**VIRGIL C. SUMMER NUCLEAR STATION (VCSNS) Unit 1
DOCKET NO. 50-395
OPERATING LICENSE NO. NPF-12**

ATTACHMENT I

Analysis of Proposed Radiation Emergency Plan Change

Figure B-1b: Onsite Emergency Response Organization

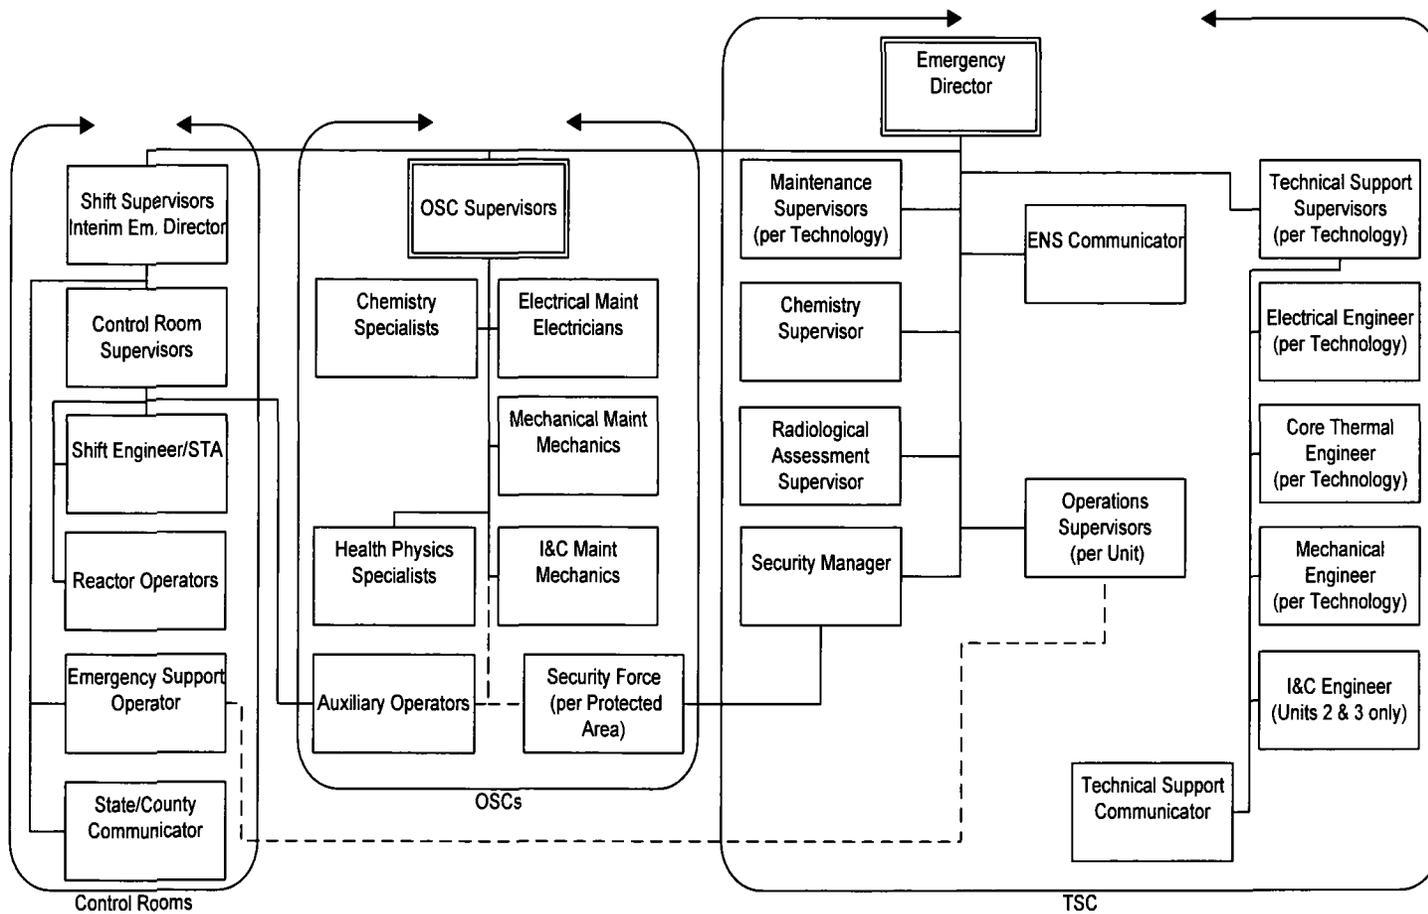
2.3	34	Part 2 Figure B-1b – Updated the organization chart to reflect changes to ERO positions in the plan
2.3	35	Part 2 Figure B-1c – Updated the organization chart to reflect changes to ERO positions in the plan

34.	Updated the organization chart to reflect changes to ERO positions in the plan	Part 2 Figure B-1b	10 CFR 50.47(b)(1)	<p>Justification: These changes support implementation of other listed emergency plan changes.</p> <p>The logistics of a multi-unit site adds aspects of command and control which were not previously used and trained or drilled at VCS. The guidance added, changes the command and control structure for emergencies to ensure proper response by personnel. The addition is needed to clearly delineate the structure and reduce the overall potential confusion for transitioning to a multi-unit site.</p> <p>Evaluation: These changes must be implemented based on the changes, justifications, and evaluations previously listed in this document. As individual changes, these may not reduce the effectiveness of the emergency plan. However, when combined together and with the change in activation times, ERO titles, ERO assignments, and relocation of the TSC, these changes reduce the</p>

Figure B-1c: Offsite Emergency Response Organization

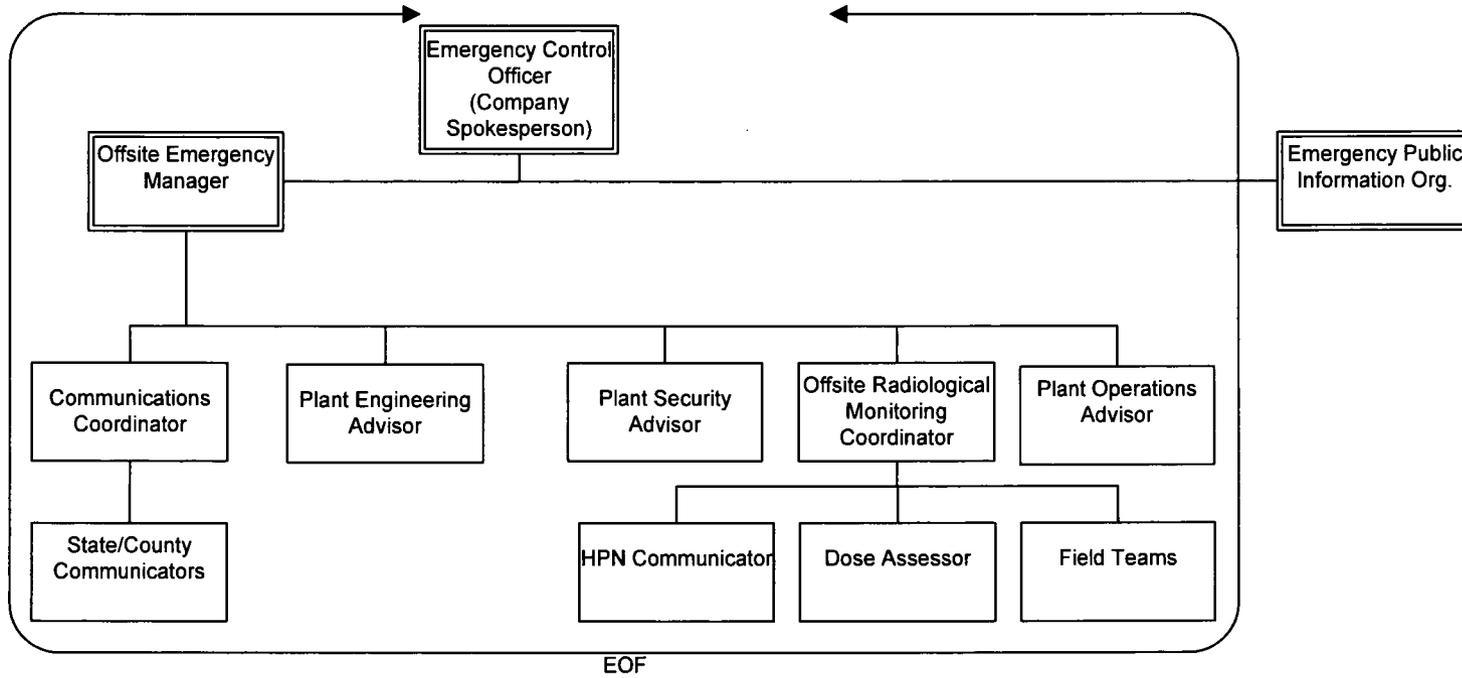
35.	Updated the organization chart to reflect changes to ERO positions in the plan	Part 2 Figure B-1c	10 CFR 50.47(b)(1) 10 CFR 50.47(b)(2) 10 CFR 50.47(b)(6) 10 CFR 50.47(b)(8)	<p>Justification: These changes support implementation of other listed emergency plan changes.</p> <p>The logistics of a multi-unit site adds aspects of command and control which were not previously used and trained or drilled at VCS. The guidance added, changes the command and control structure for emergencies to ensure proper response by personnel. The addition is needed to clearly delineate the structure and reduce the overall potential confusion for transitioning to a multi-unit site.</p> <p>Evaluation: These changes must be implemented based on the changes, justifications, and evaluations previously listed in this document. As individual changes, these may not reduce the effectiveness of the emergency plan. However, when combined together and with the change in activation times, ERO titles, ERO assignments, and relocation of the TSC, these changes reduce the effectiveness of the emergency plan and require prior approval by the NRC. The changes continue to meet the requirements of 10 CFR 50.47(b) and 10 CFR 50 Appendix E. See the Technical Evaluation Section 4.3 of the LAR ATTACHMENT I.</p>

Figure B-1d: Emergency Public Information Organization

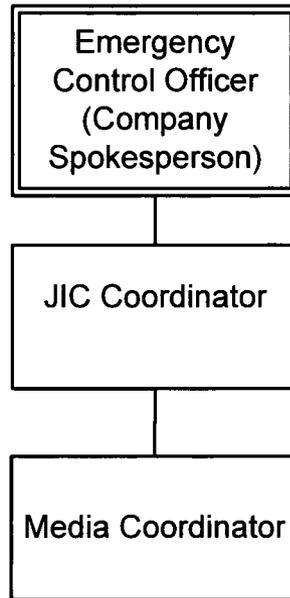
2.3	36	Part 2 Figure B-1d – Updated the organization chart to reflect changes to ERO positions in the plan
2.3	37	Part 2 Table B-1a – Updated the table to include changes affecting ERO positions, augmentation times, and responsibilities

36.	Updated the organization chart to reflect changes to ERO positions in the plan	Part 2 Figure B-1d	10 CFR 50.47(b)(1) 10 CFR 50.47(b)(2) 10 CFR 50.47(b)(6)	<p>Justification: These changes support implementation of other listed emergency plan changes.</p> <p>The logistics of a multi-unit site adds aspects of command and control which were not previously used and trained or drilled at VCS. The guidance added, changes the command and control structure for emergencies to ensure proper response by personnel. The</p>
